SnowDoggby **Buyers****TECHNICAL
SERVICE BULLETIN**

NUMBER	16TSB-63			TYPE	SERVICE/INSTALL ALERT			
ROUTING	INSTALL	X	SERVICE	X	SALES		PURCH	
TITLE	2015+ F150 BATTERY CONNECTION							
REV	A			ISSUED	11/9/2015		REVISED	-
AFFECTS	ALL SNOWDOGG PLOW INSTALLATIONS ON 2015+ FORD F150 TRUCKS							
INFORMATION	PLEASE REVIEW FORD SVE BULLETIN Q-231 AS ATTACHED							
INSTRUCTIONS	CONTACT SNOWDOGGTECH@BUYERSPRODUCTS.COM WITH ANY QUESTIONS.

QVM Bulletin: Q-231

F-150 Aftermarket Direct to Battery Connections

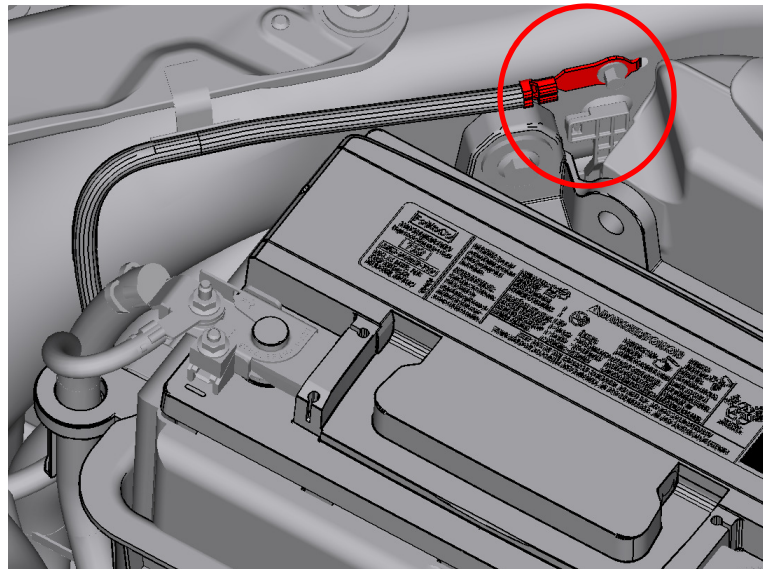
Description: The 2015MY F-150 battery charge state is determined with a Hall Effect sensor on the negative battery lead. All negative current must pass through this sensor. Failure to do so will result in malfunction of the vehicle charging system and shortened battery life. **Do not make direct to battery connections at the negative battery post.**

Procedure: To ensure proper charging system function, the battery return should be made at the grounding point shown and circled in red in the picture below:

Addition grounding point specifications:

Eyelet ID: 7mm
Bolt: M6
Torque: 9 +/- 1.4 Nm
